Current Zoning: RE-1 (research district)
Proposed Zoning: UR-2(CD) (urban residential, conditional)

Approximately 6.94 acres located at the northwest corner of William Ficklen Drive and Ben Craig Drive, west of Mallard Creek Road and east of WT Harris Blvd.

The petition proposes development of a vacant site in the University Research Park area for up to 82 single-family attached townhomes.

STAFF RECOMMENDATION

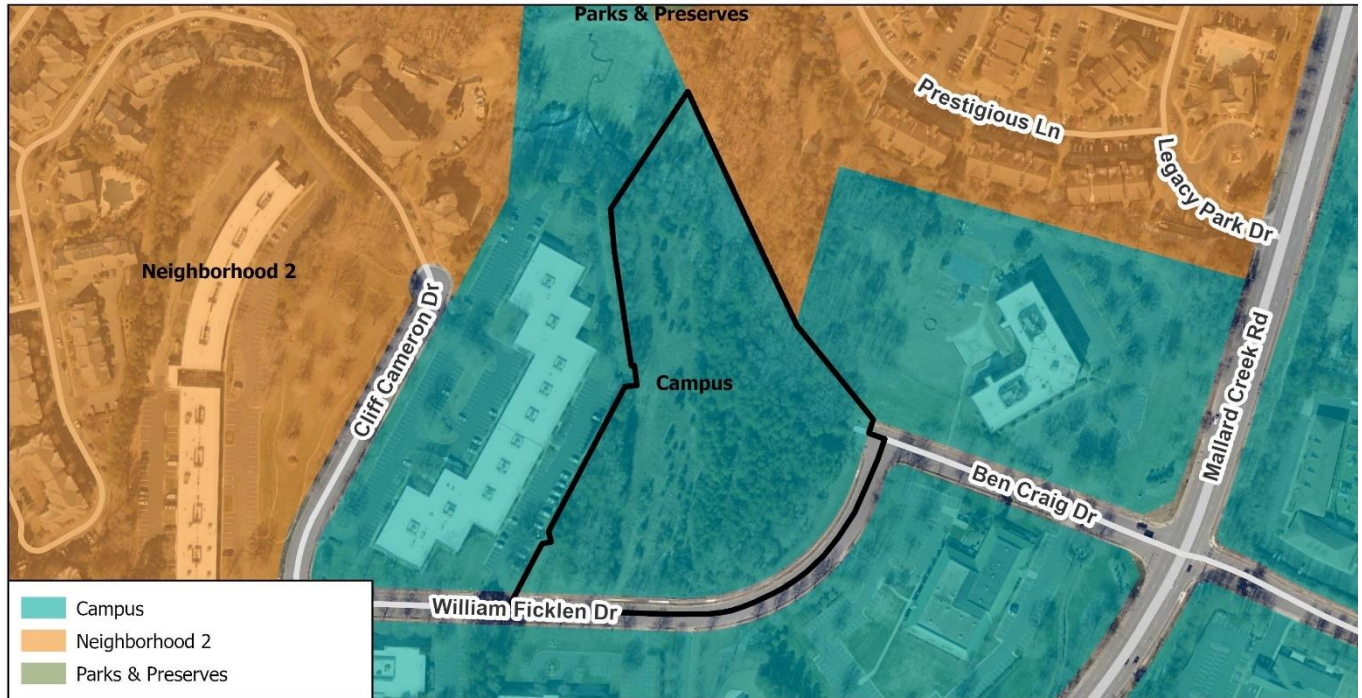
1. Add a conditional note specifying "A Right-of-Way Encroachment Agreement is required for the installation of any non-standard item(s) (irrigation systems, decorative concrete pavement, brick pavers, etc.) within a proposed/existing City-maintained street right-of-way by a private individual, group, business, or homeowner's/business association. An encroachment agreement must be approved by CDOT prior to construction/installation. Contact CDOT for additional information concerning cost, submittal, and liability insurance coverage requirements."

2. Revise conditional notes to commit to meeting all Intersection sight distance requirements along William Ficklen Drive frontage. If ISD cannot be met changes to site access will be required.

3. Revise conditional note(s) to commit to meeting intersection sight distance requirements. Site entrance locations will be required to meet all ISD requirements.

4. Revise site plan to show proper separation between the proposed on-street parking and the intersection. A minimum of 20-feet is required from the curb return to the parking stall.

5. Add a conditional note specifying "All transportation improvements will be approved and constructed before the site's first building certificate of occupancy is issued. The petitioner may phase transportation improvements if said improvements and phasing are explicitly described in site plan notes."

6. Provide an 8 foot sidewalk and an 8 foot planting strip along frontage of William Ficklen Drive.
